T10/07-391 revision 2

Date: December 14, 2007

Subject: SAS-2: Limiting SAS Target response to OPEN_REJECT (RETRY)

Figure 1 — Port layer examples

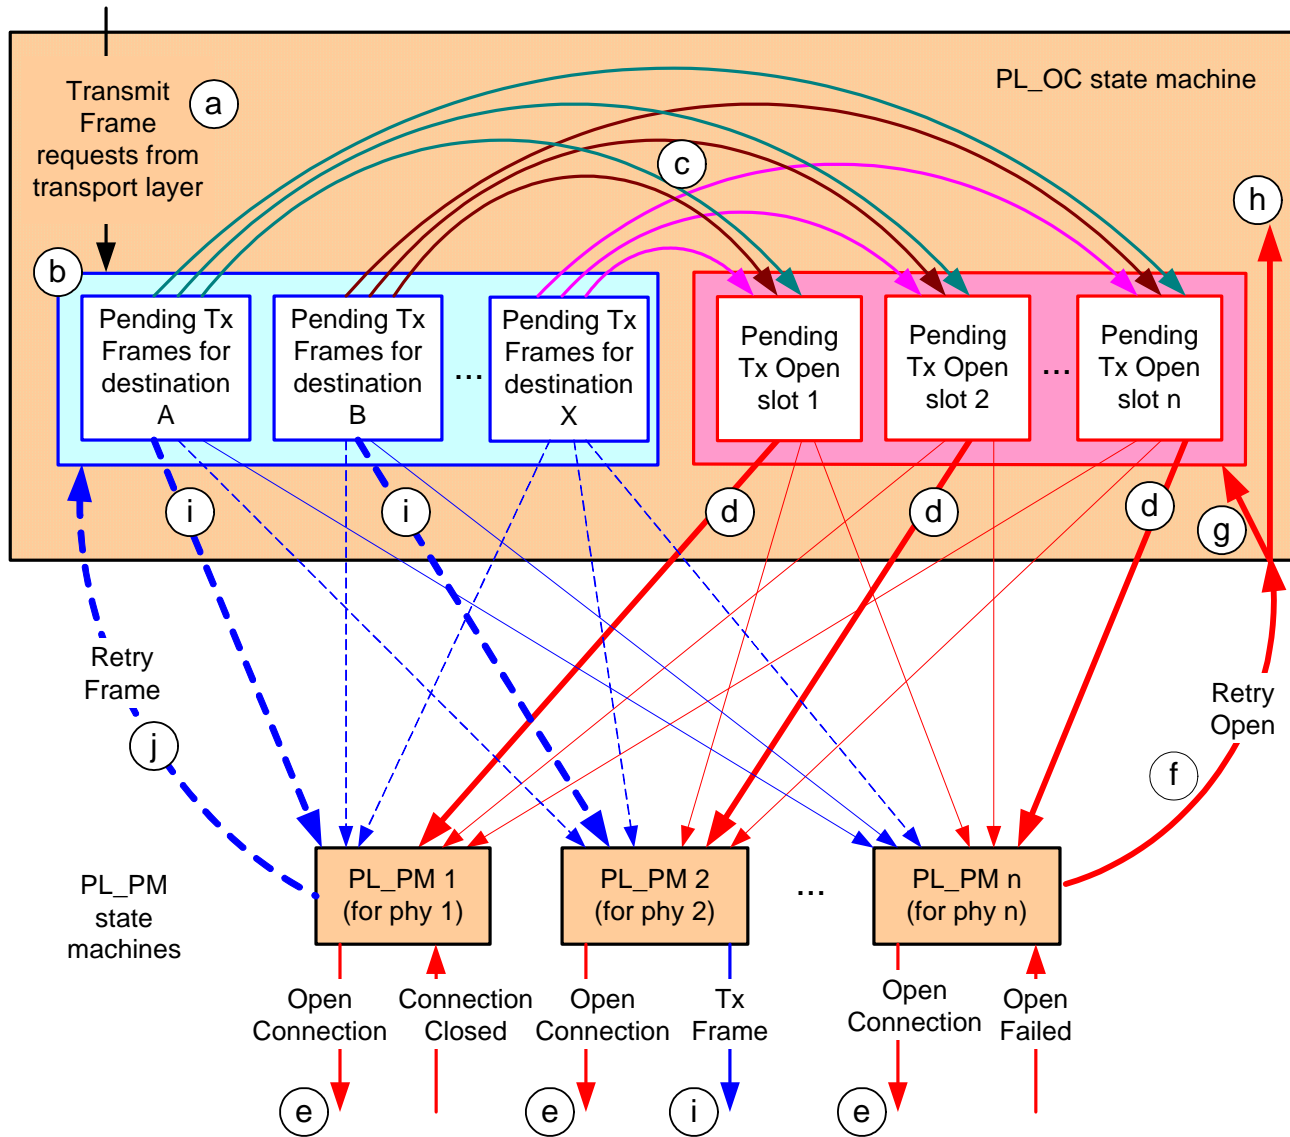
- g) ~~the PL_OC state machine converts a Retry Open message to a pending Tx Open message if there is a pending Tx Open slot available; if the PL_OC state machine converts a Retry Open message into a pending Tx Open message, then the pathway blocked count and arbitration wait time context from the Retry Open message are applied to the pending Tx Open message;~~

- h) after the reject to open limit timer, if any, has expired, and if there is a pending Tx Open slot available, then the PL_OC state machine converts a Retry Open message to a pending Tx Open message with the pathway blocked count and arbitration wait time context from the Retry Open message applied to the pending Tx Open message;

- i) if the PL_OC state machine does not convert a Retry Open to a pending Tx Open frame, then the PL_OC discards the Retry Open message. The PL_OC state machine may create a new Tx Open message for the same pending Tx Frame at a later time. If the PL_OC state machine discards a Retry Open message, then the pathway blocked count and arbitration wait time context from the Retry Open message are also discarded;
